**Our Case Number:** ABP-314724-22

**Re:** Railway (Metrolink - Estuary to Charlemont via Dublin Airport) Order [2022]  
Metrolink. Estuary through Swords, Dublin Airport, Ballymun, Glasnevin and City Centre to Charlemont,  
Co. Dublin

**Observation; TII “Railway (Metrolink-Estuary to Charlemont via Dublin Airport) Order 2022”**

**Fig 1: IALPA proposed Twin Bore Dublin Airport Track layout (May 2018).**

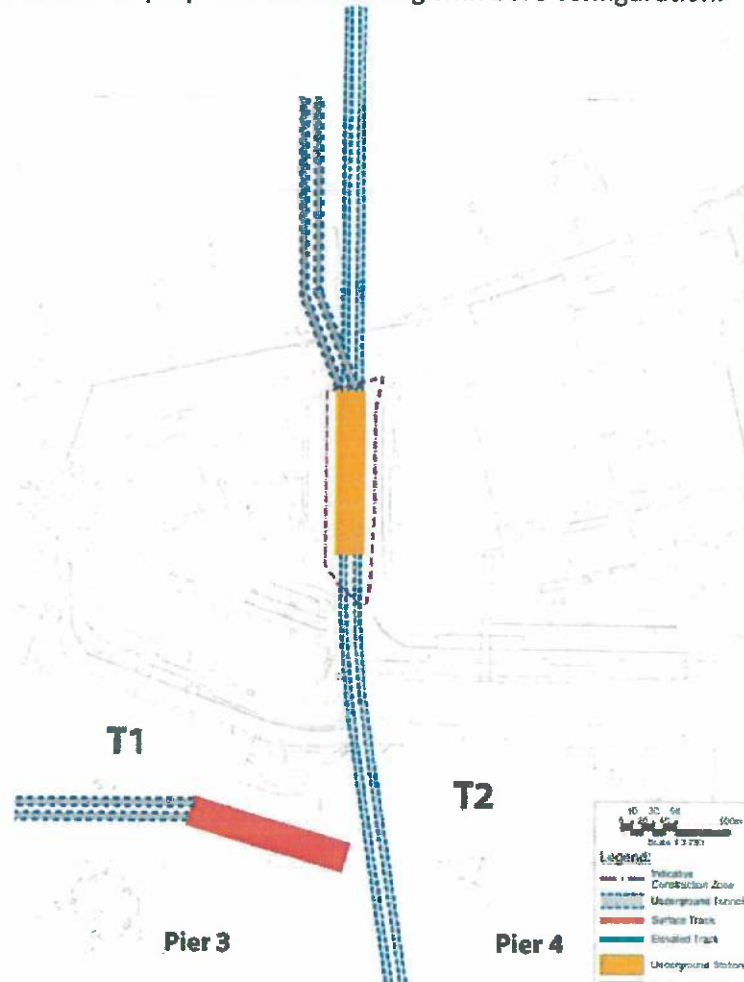
In our initial submission we proposed the following twin bore configuration.

**Note:** This Map also include our recommended APM (Automatic People Mover) connection to the Western Campus.

**Fig 2: IALPA Proposed Single Bore Dublin Airport Track layout (April 2019).**

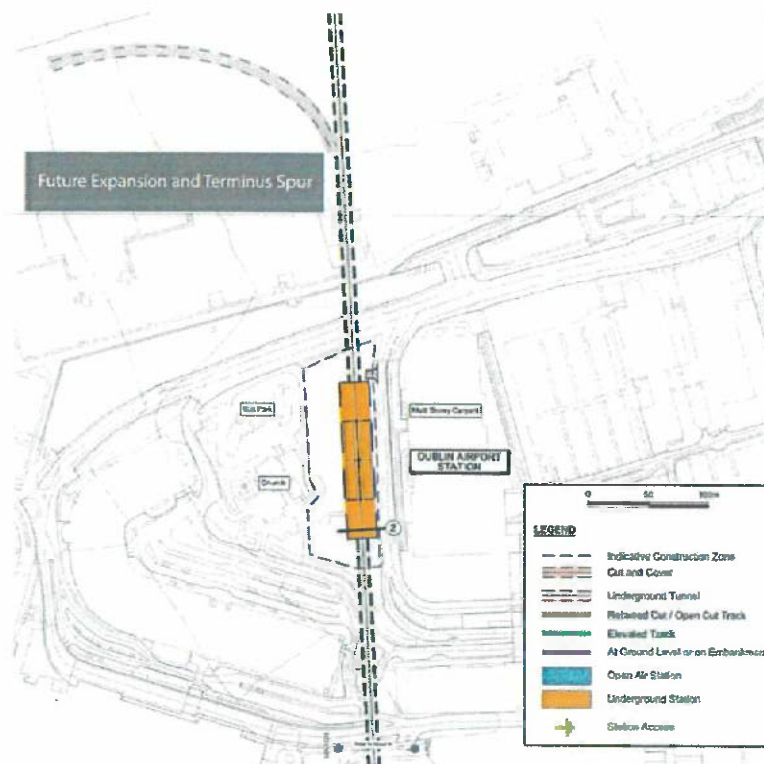
Since the NTA has elected to develop a single Bore Tunnel design we recommend the following simple split North of the Dublin Airport Station or Alternatively construct a Turn back at Emerging Route "Sheet 6" with an additional Mine for future expansion capability just North of the Airport Station to eventually serve the Western Campus / T3 Terminus?

If constructed this Auxiliary spur Tunnel shall:

- Provide immediate capability to enable dedicated (rapid) Airport service Terminus Turnback.
- The facility to store Airport Specific Trams (Enhanced Luggage stowage trams) supplied as required from the Dardistown Depot Facility.
- Future proof a dedicated airport Terminus service, combining capacity for passenger expansion.
- Facilitates a FCC / DAA requirement to develop Pier and/or Terminal 3 facilities out West.

- The drill bit / head of the TBM may be sacrificed at the Tunnel end?
- Too expensive when a mined section may suffice?

**Fig 4: The Feb 2019 DAA APM proposal, linking T1 & T2 with the Western Campus now mirrors our Fig 1 above and Fig 5 Below.**

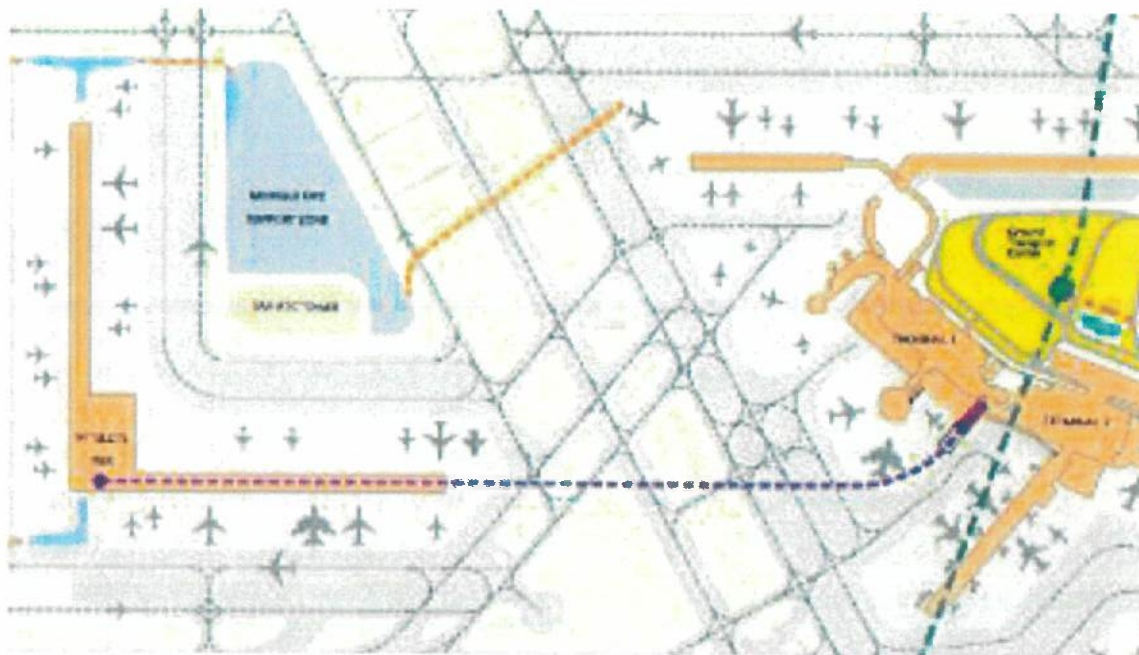
This underpass combined with further DAA expansion plans to 50mppa shall incorporate an internal APM (Automatic People Mover) to the Western Campus.

Being cognizant of ABP and FCC's acknowledged congestion concerns surrounding the M1 - M50 / Swords Corridor. We submit that the combined outstanding decision for both the DAA and the NTA is to define now the eventual location of T3.

Fig1: Airport Box with the "Eastern" and "Western" Campus delineated by the Cross Runway 34/16.

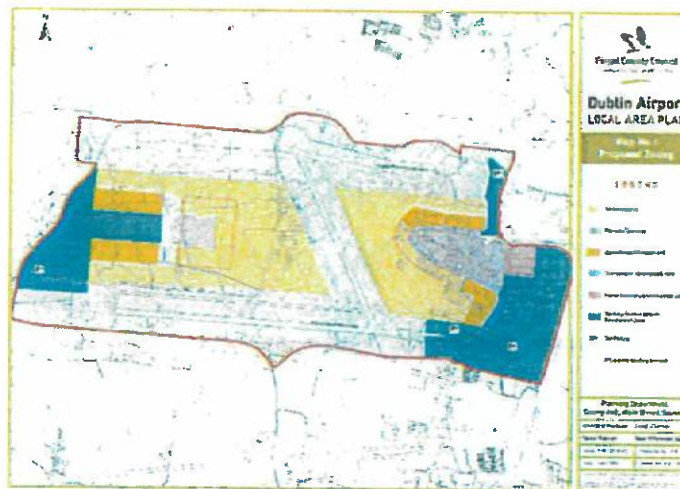
We emphasised a holistic requirement to fully integrate all future modes of transport contained in the Fingal County Council (FCC) LAP (Local Area Plan) "Airport Box" with TII Metro system.
